AR-07-1162

Southern Nuclear Operating Company
Vogtle Early Site Permit Application
Supplemental Response to Requests for Additional Information on Geology/Seismology

**Supplemental Response to Geology/Seismology RAIs
on the
Vogtle ESP Application**

Figure 1. Comparison between the linear average of the suite of 30 spectrum compatible time histories (red line), target spectrum (thick gray line), target spectrum divided by 1.1 (dashed blue line), and target spectrum multiplied by 1.3 (dashed green line) for the high frequency 10⁻⁴ case.

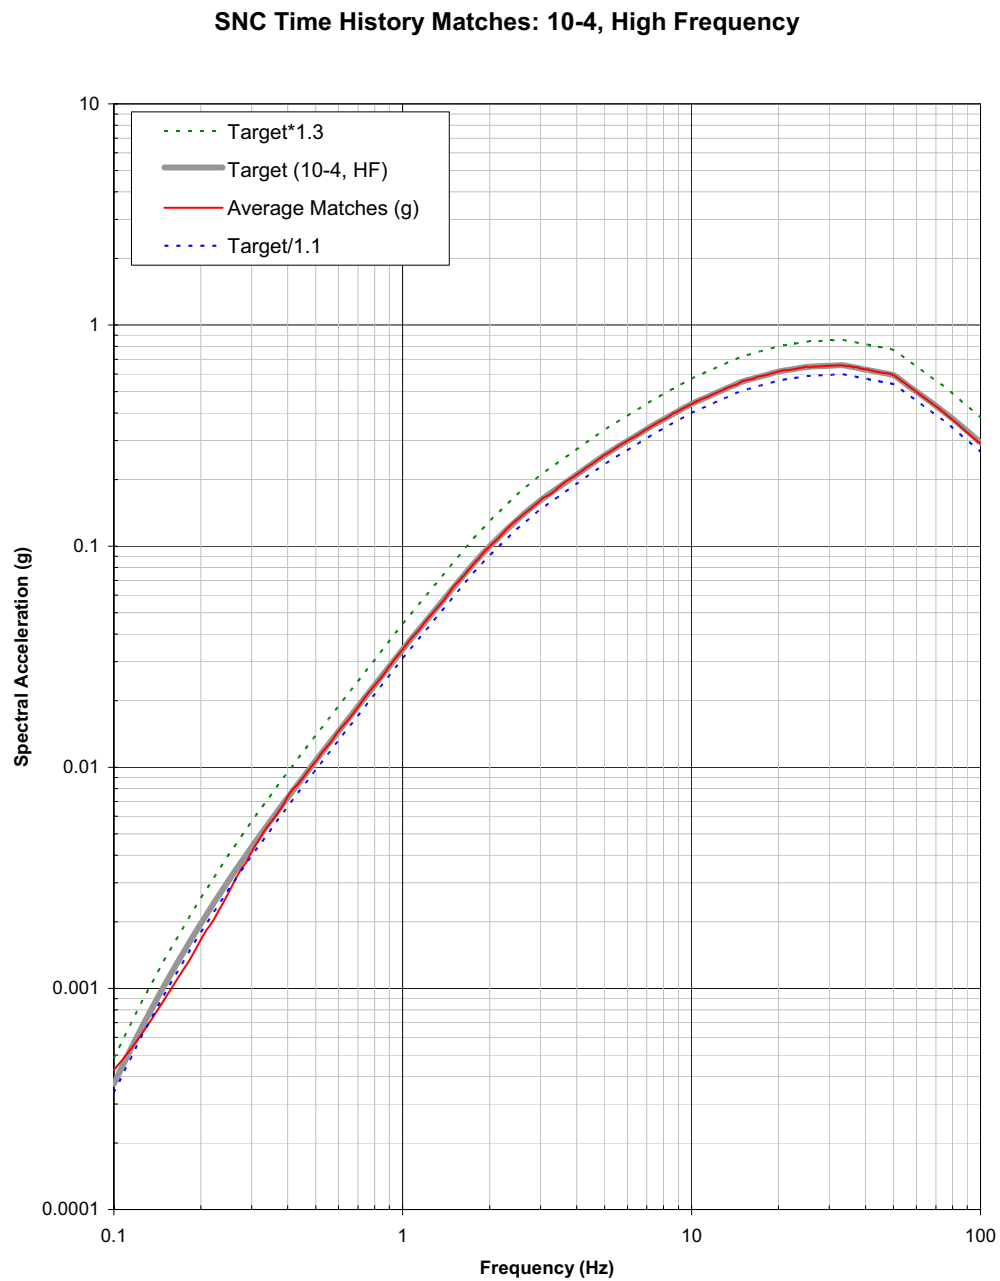
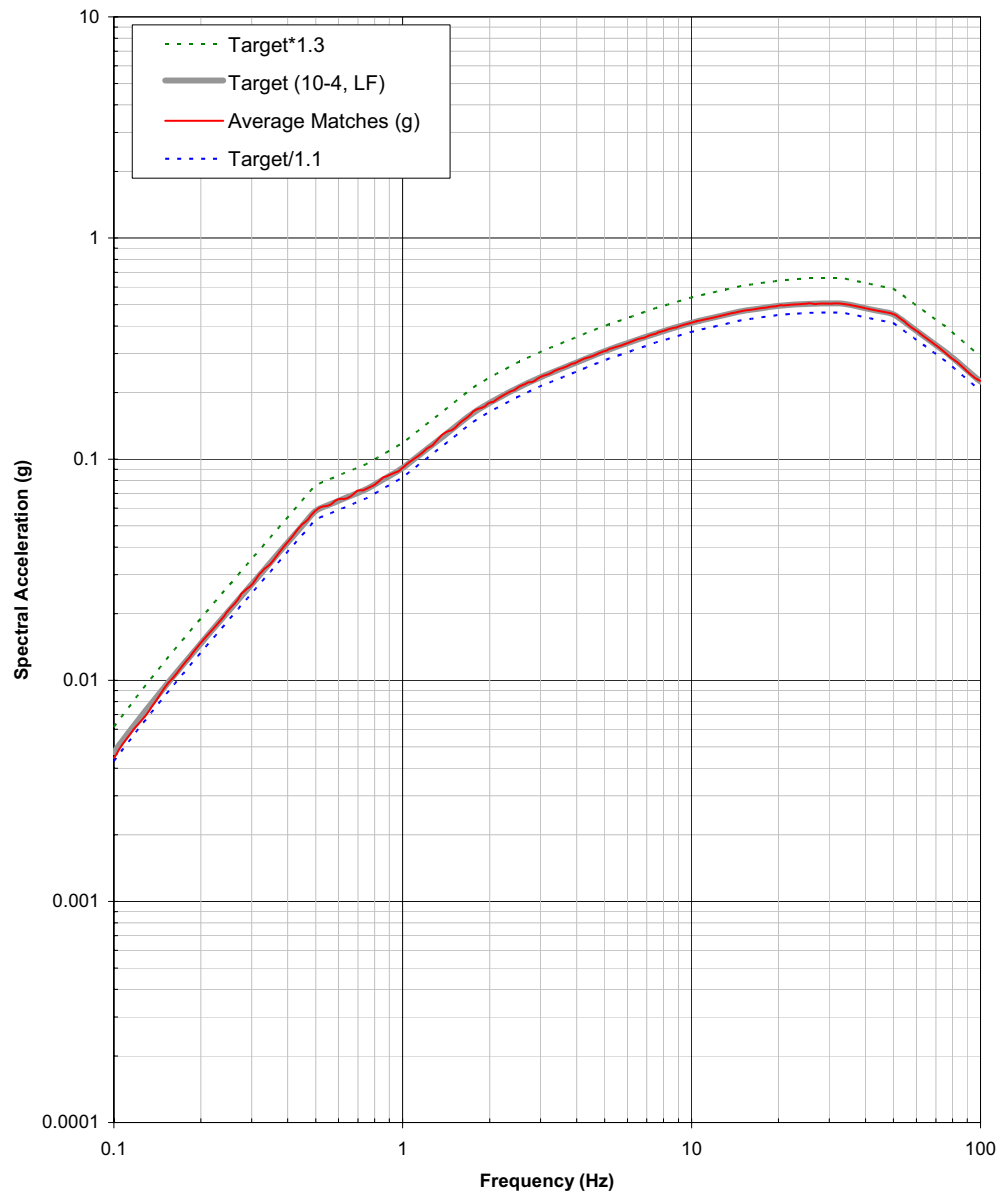
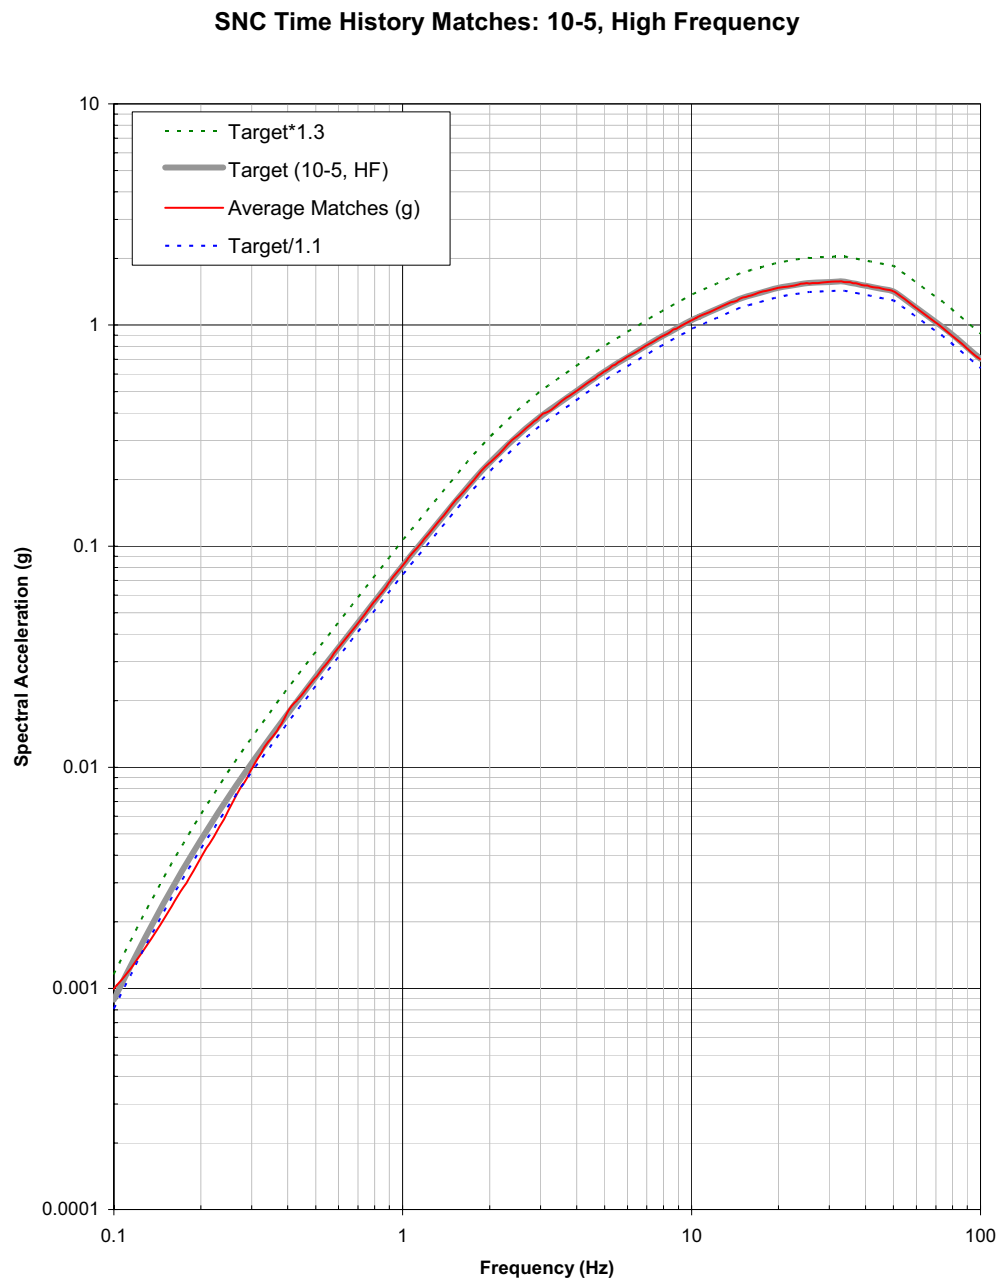
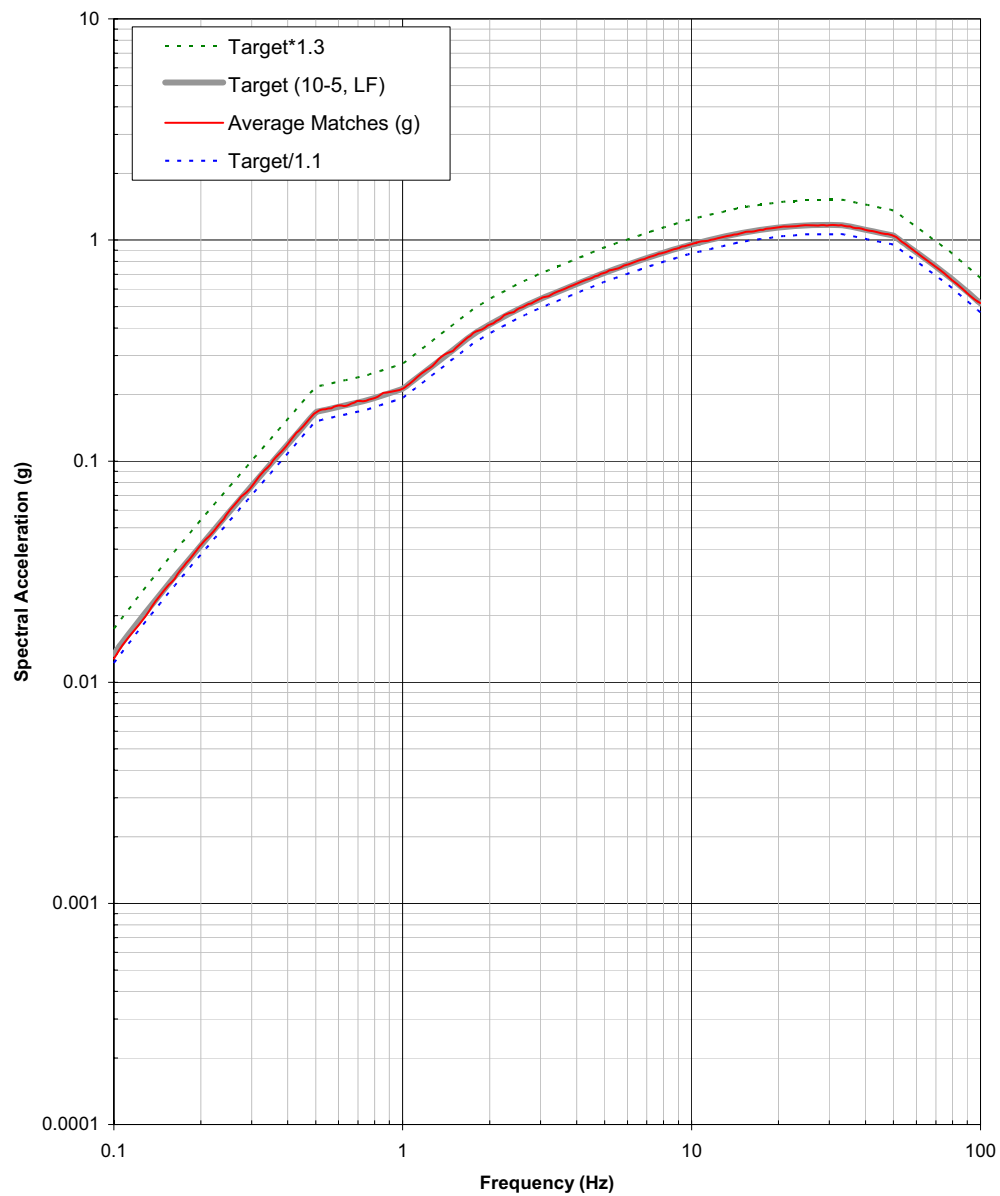
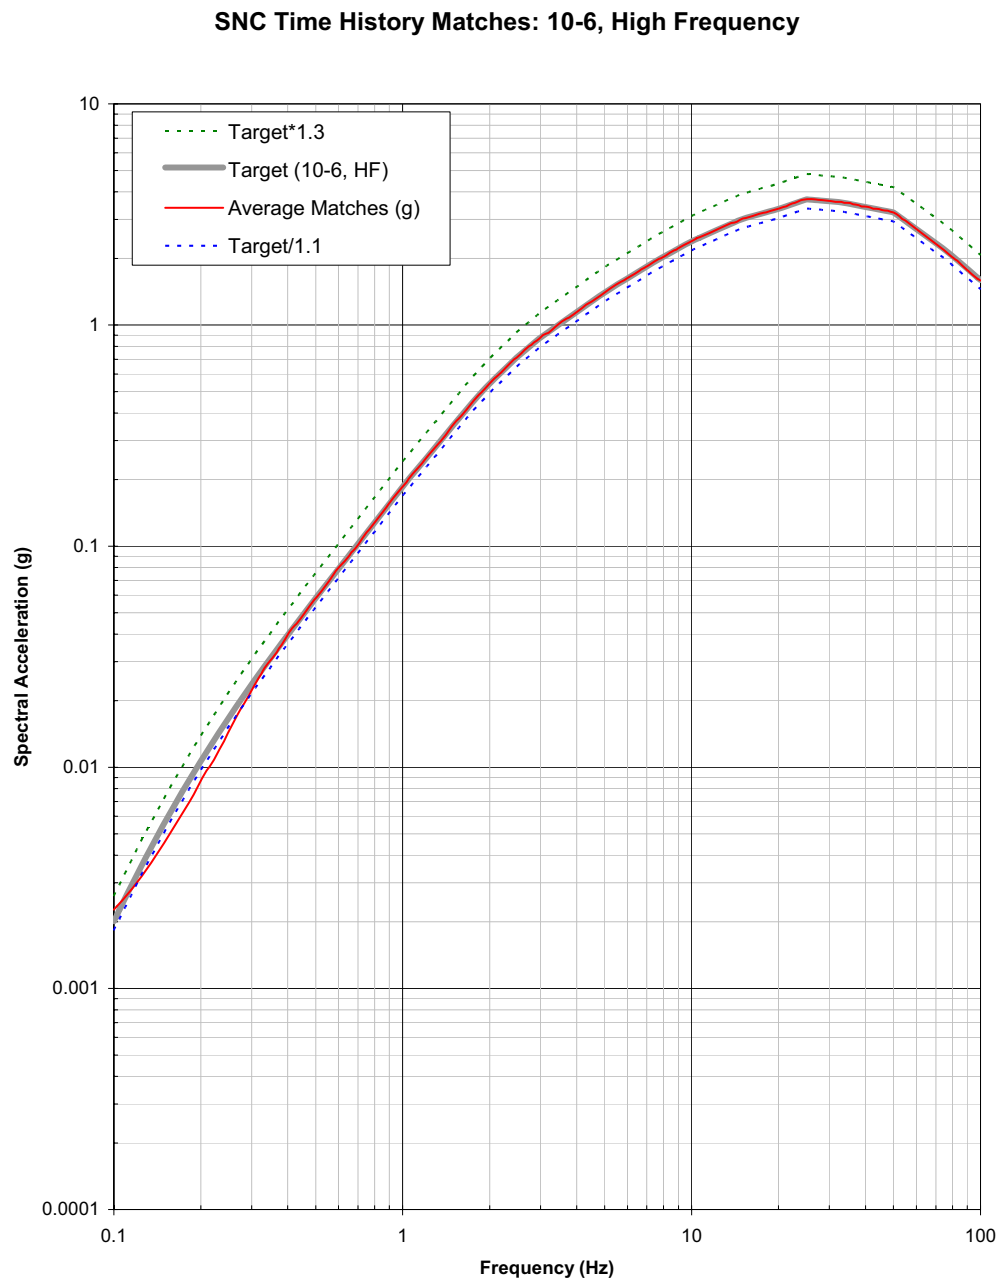
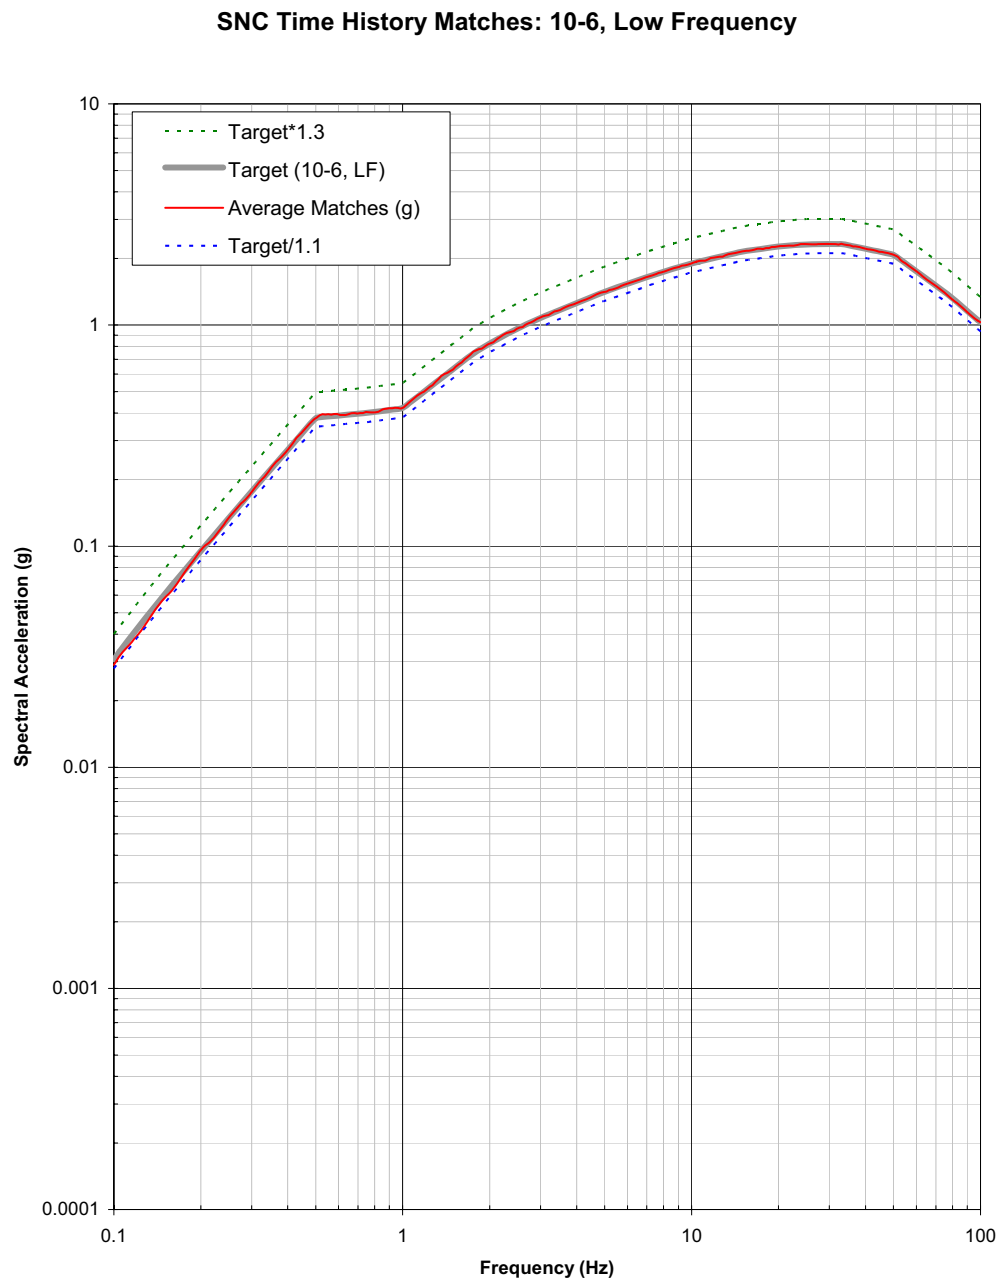
Please explain whether the additional criteria listed in NUREG/CR-6728 were also satisfied. If these additional criteria were not satisfied, please provide justification for not doing so.

For the site response analysis, 30 acceleration horizontal time histories were modified to be spectrum compatible to given target spectra. Target spectra were developed for both the high- and low-frequency cases at each of the three annual probability levels: 1×10^{-4} , 1×10^{-5} , and 1×10^{-6} . This resulted in a total of 180 spectrum compatible acceleration time histories for the site response analysis. For a given suite of 30 time histories, the spectral matching criteria given in NUREG CR-6728 were used as guidance.

As specified in the NUREG CR-6728 spectral matching criteria, when using multiple sets of time histories, the mean (linear average) of the 5% damped response spectra (in this case for a given suite of 30 matches) can be used in place of the individual 5% damped response spectra for checking against the target response spectra. Criteria (a), (d), and (e) define the matching requirements for the mean response spectra and the given target response spectra. These criteria are defined for the frequency range of 0.2 to 25 Hz. For the three low frequency cases (i.e., 10^{-4} , 10^{-5} , and 10^{-6}) the mean of the suite of spectrum

Criterion (f) presents guidance on the resulting peak ground motion ratios (e.g., PGV/PGA and $PGA*PGD/PGV^2$) and Arias duration of the spectrum compatible time histories. During the spectral matching procedure for each individual time history, an emphasis was placed on maintaining the Arias duration of the initial input starting time history. In addition, the overall phasing of the input acceleration, velocity, and displacement time history was maintained during the spectral matching procedure. Thus, the Arias duration and the relative peak ground motion values were maintained to be consistent with the original input empirical strong ground motion recordings during the spectral matching analyses.

Finally, criterion (g) was not checked because it does not apply. The site response analyses were performed for a single horizontal component not pairs of horizontal components.
